TIER 1 SEISMIC EVALUATION
Immediate Occupancy Structural Performance Level
Campbell City Hall
Campbell, California

Final Report

Prepared For:
City of Campbell
70 North First Street
Campbell, California

Prepared By:
Biggs Cardosa Associates, Inc.
101 California Street, Suite 875
San Francisco, California

SECOND FLOOR PLAN

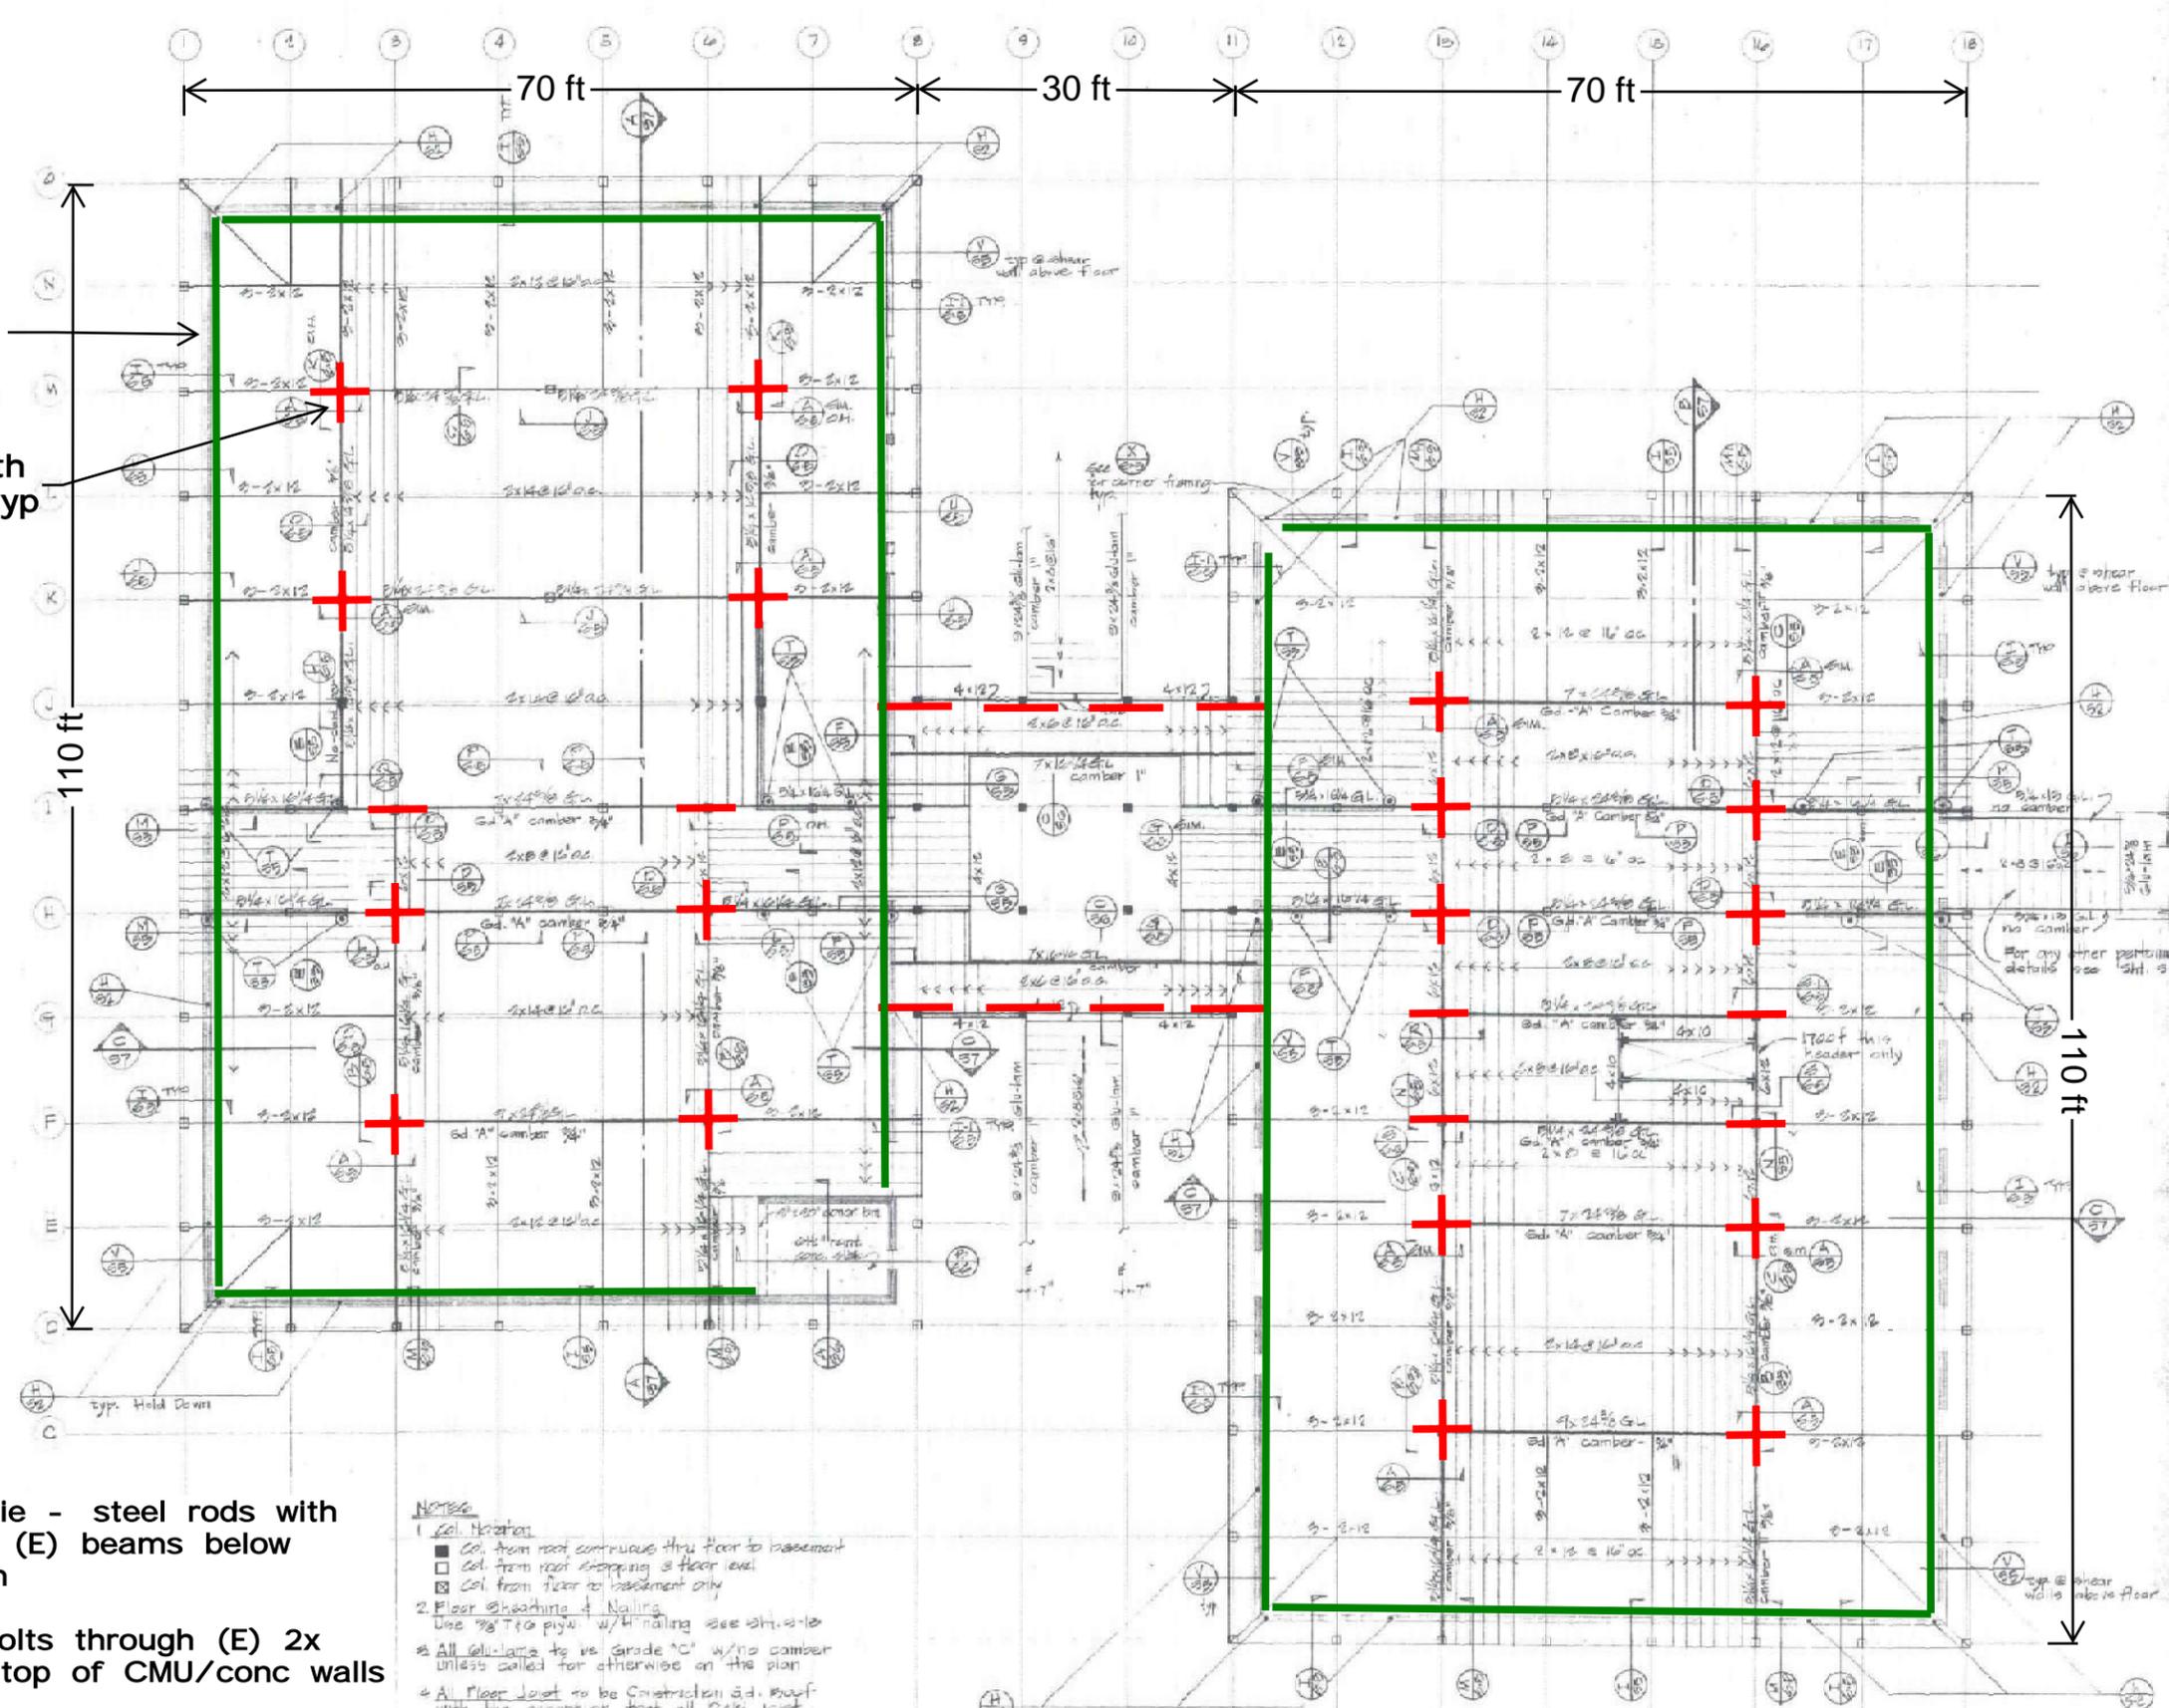
Holdowns with steel rods, typ

- Indicates (N) seismic tie - steel rods with holdowns each side of (E) beams below second floor diaphragm
- Indicates (N) anchor bolts through (E) 2x wood sill epoxied into top of CMU/conc walls at 4'-0" on center

LOWER ROOF PLAN

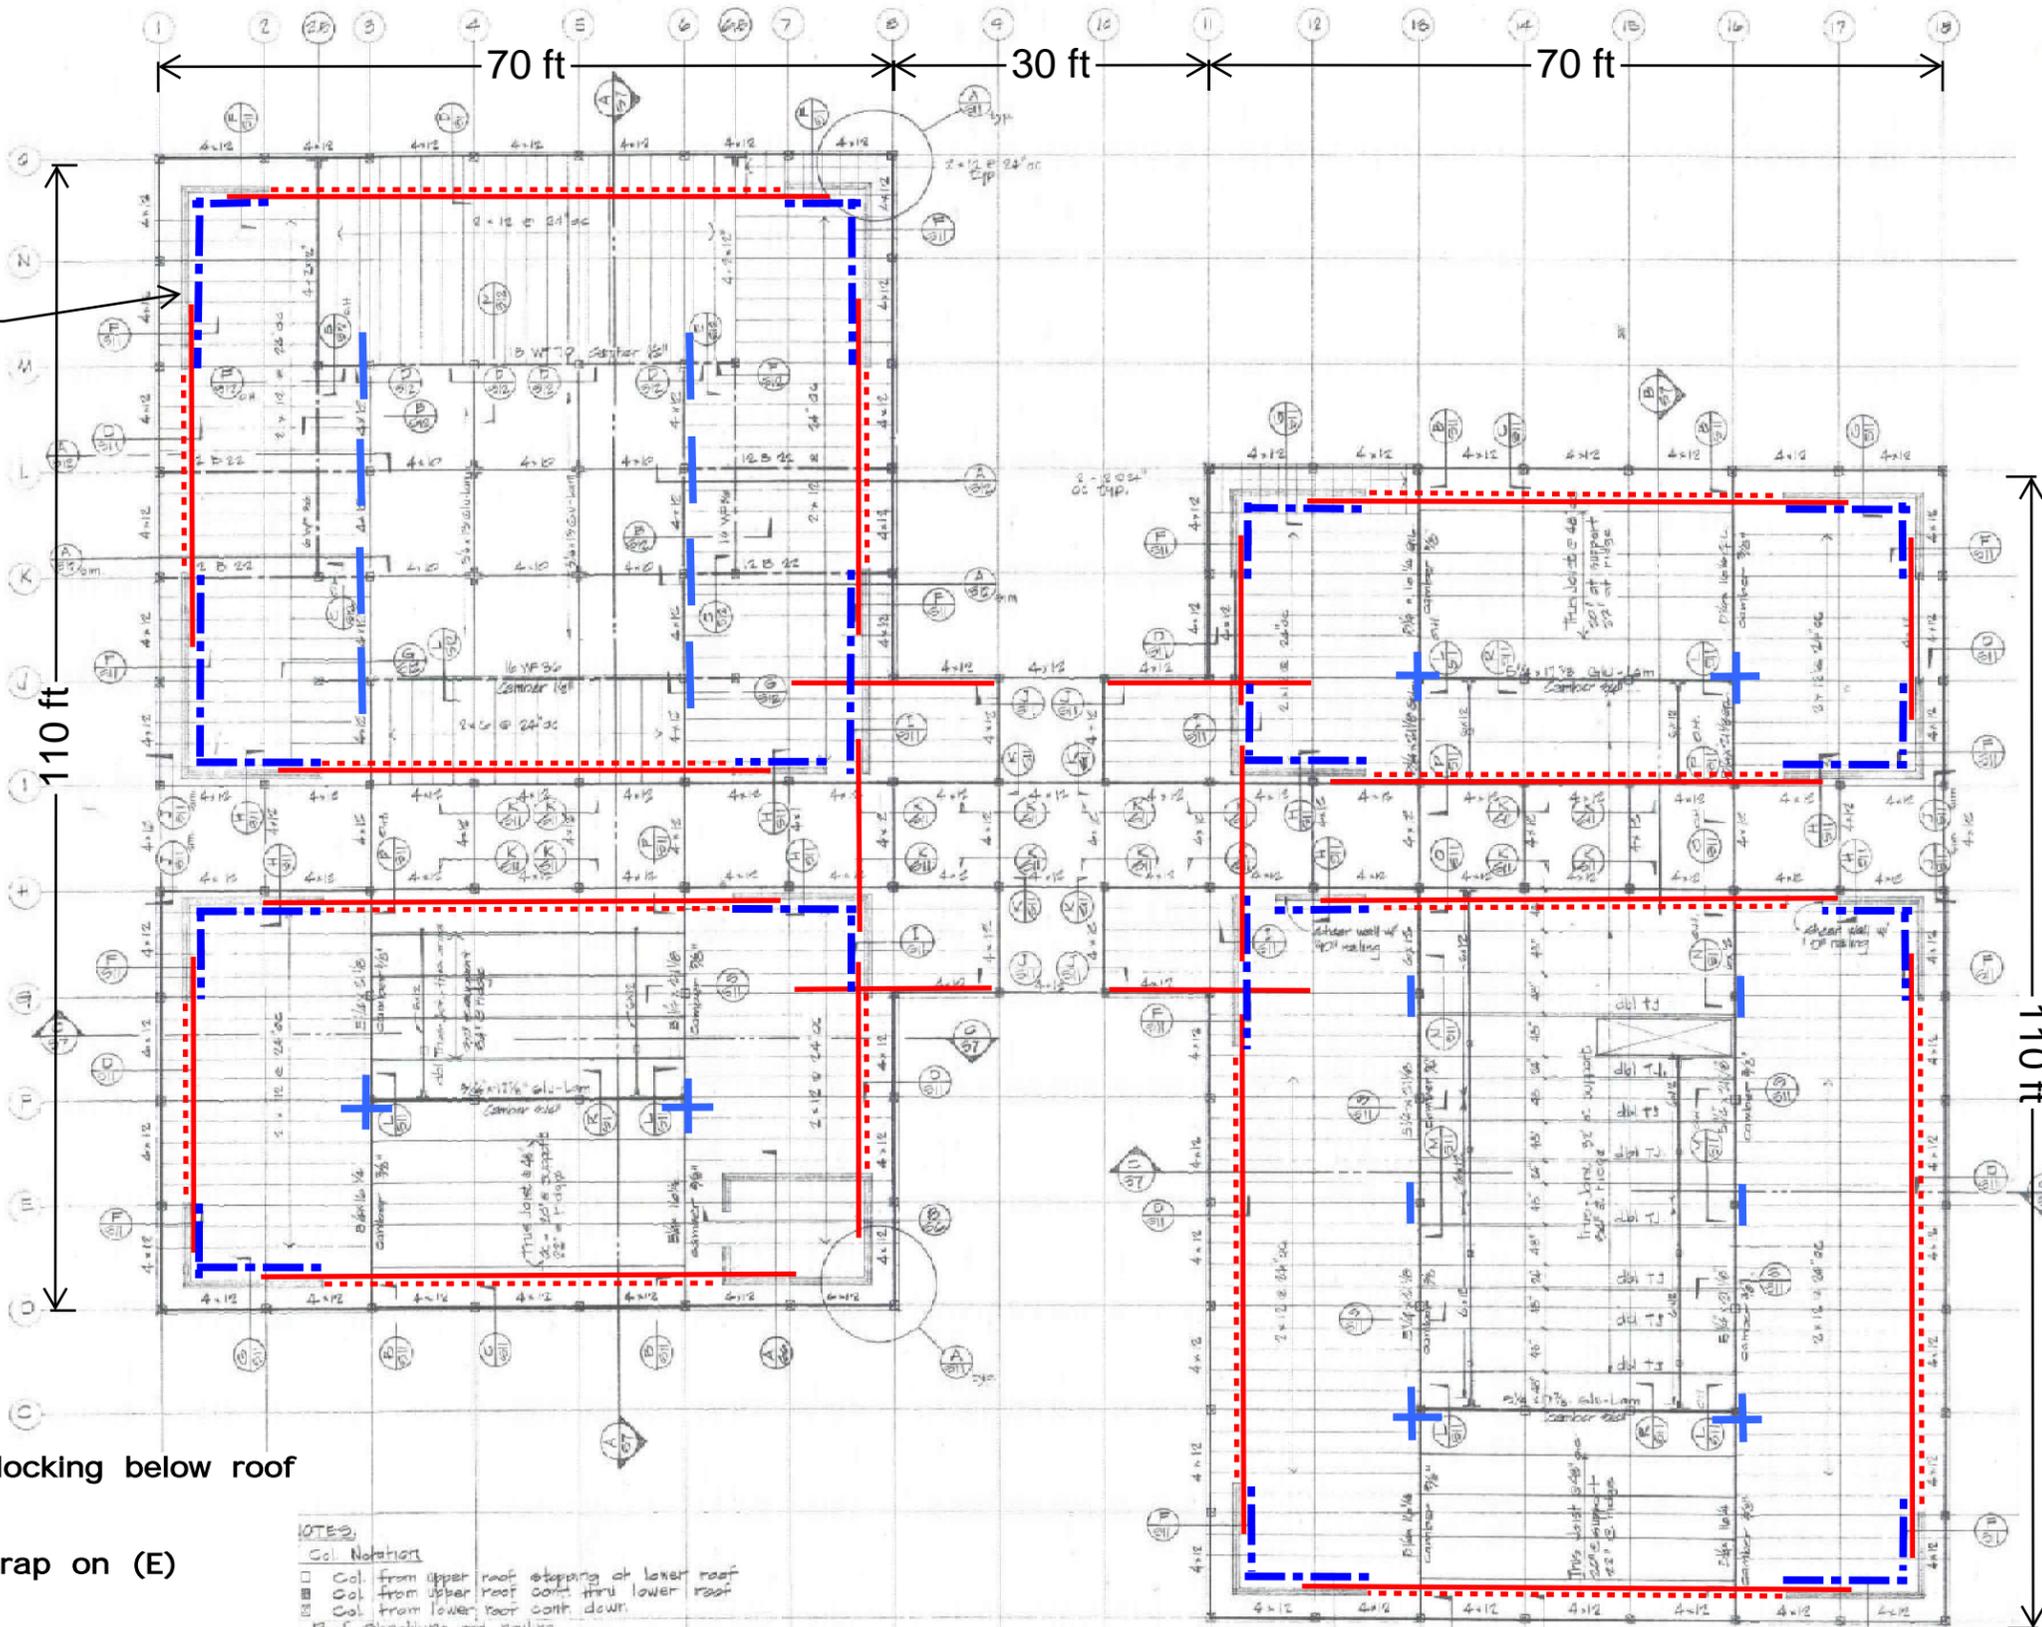
- - - - - Indicates (N) wood blocking below roof diaphragm
- Indicates (N) steel strap on (E) plywood diaphragm
- - - - - Indicates additional (N) plywood at (E) shearwalls with holdowns
- Indicates (N) seismic tie - steel rods with holdowns each side of (E) beams below lower roof diaphragm

HIGH ROOF PLAN

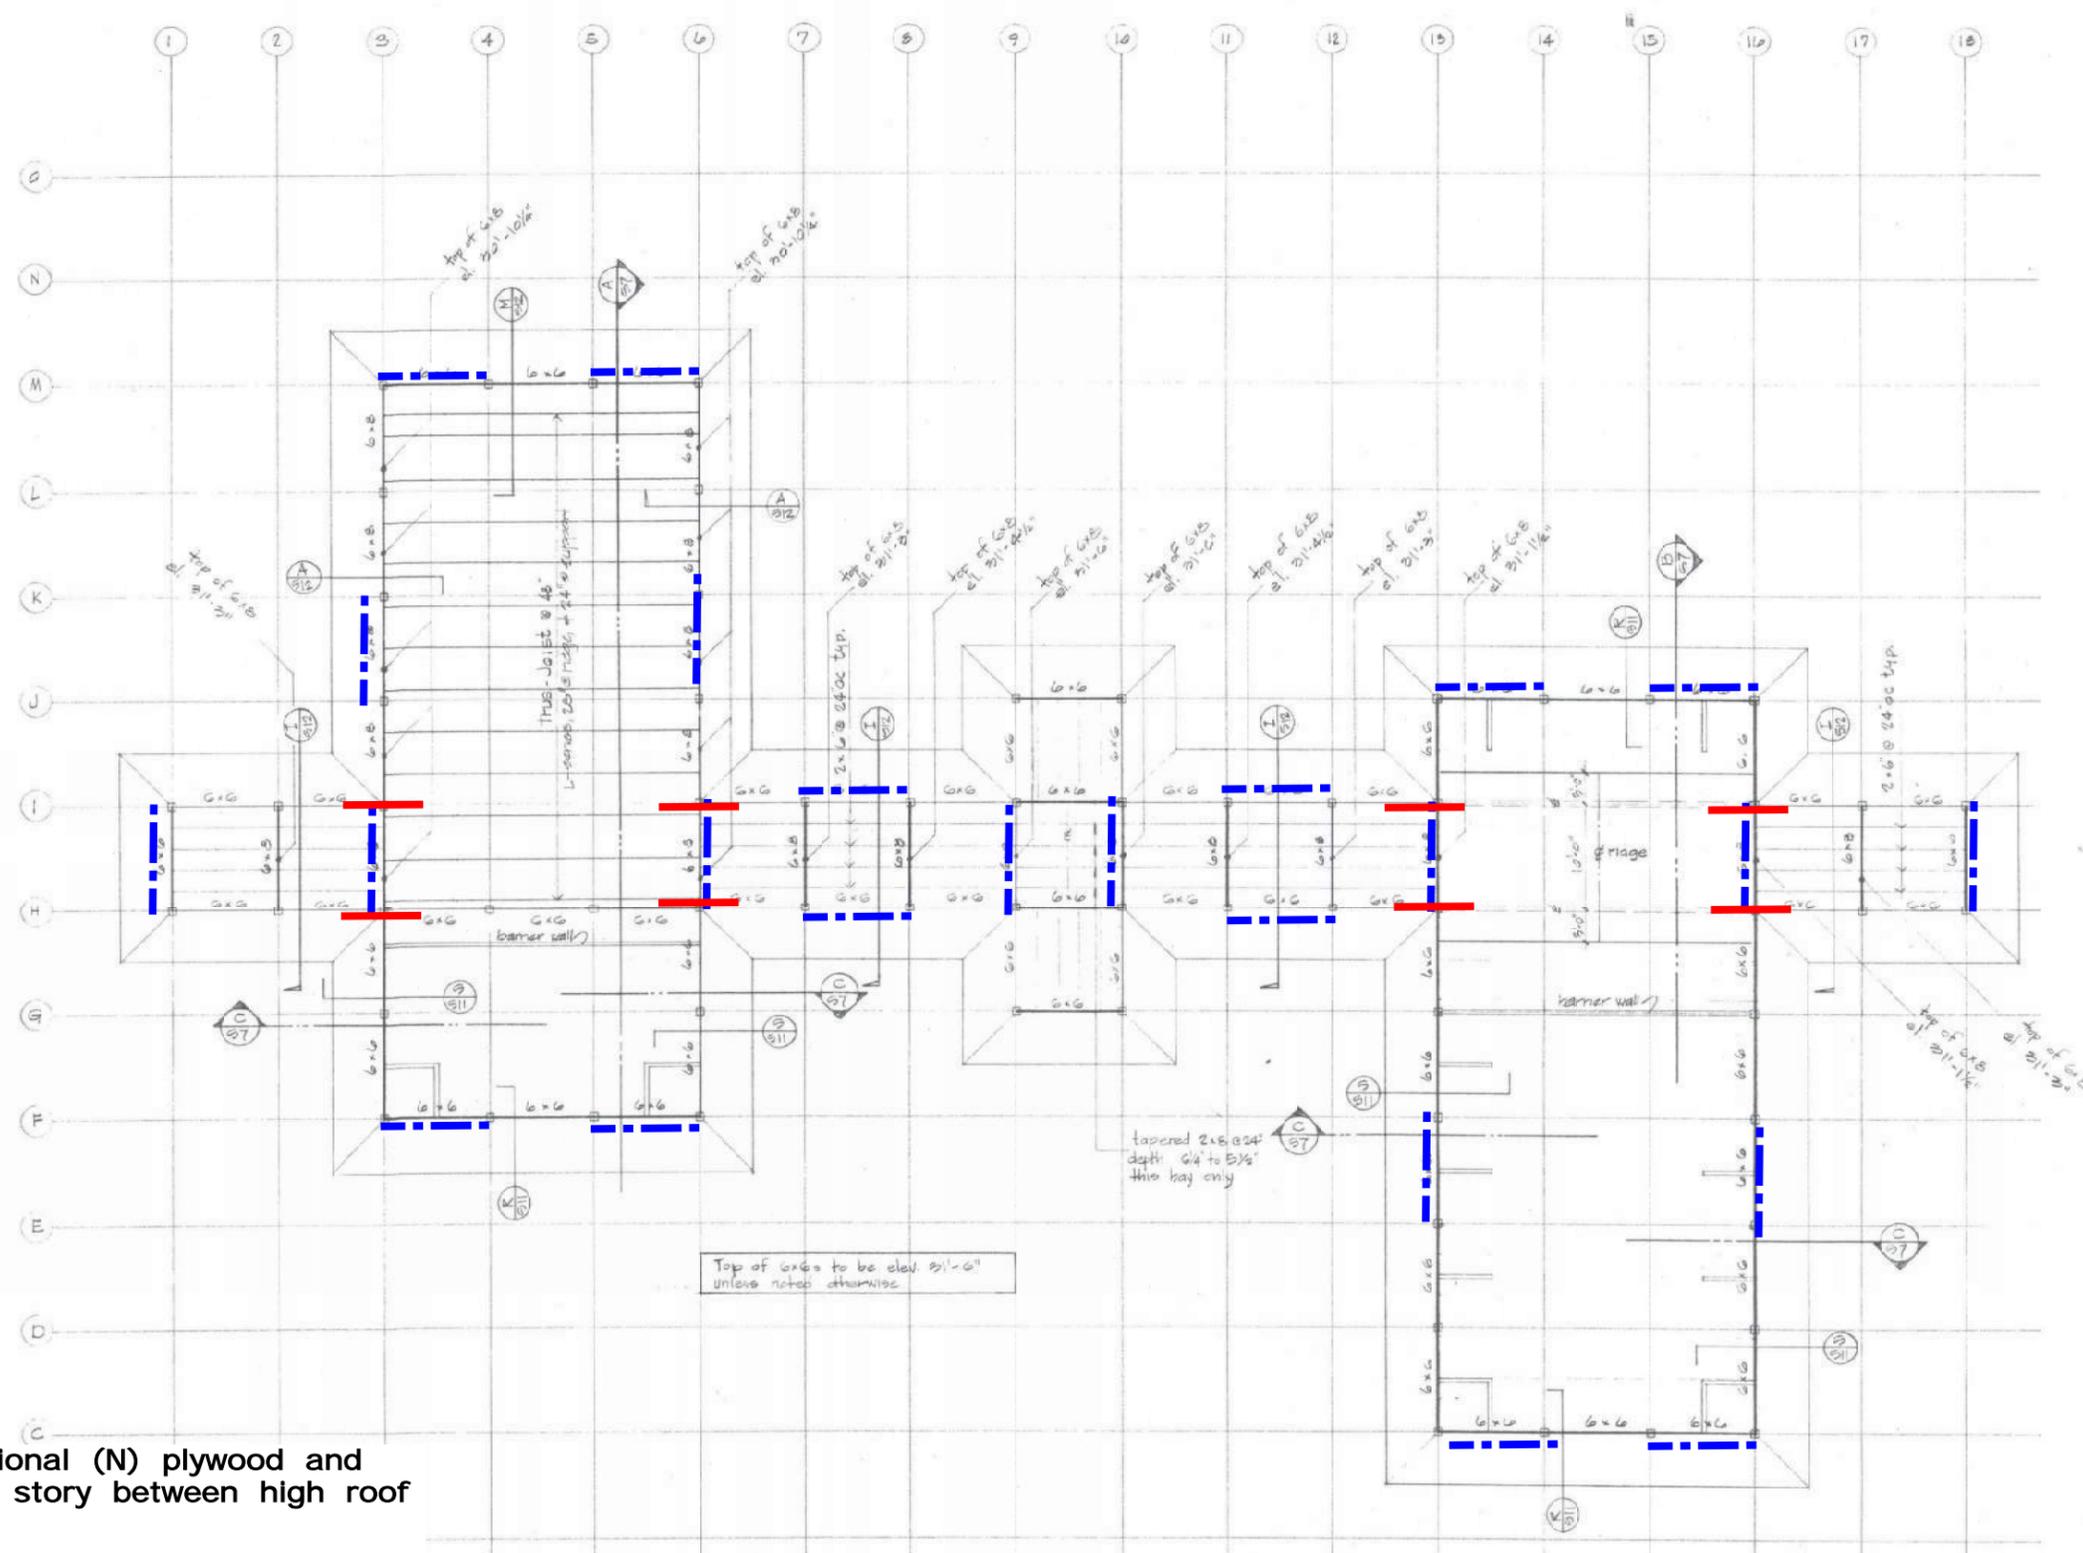
- - - - - Indicates additional (N) plywood and studs at clear story between high roof and low roof

————— Indicates (N) seismic tie - steel rods with holdowns each side of (E) beams below high roof
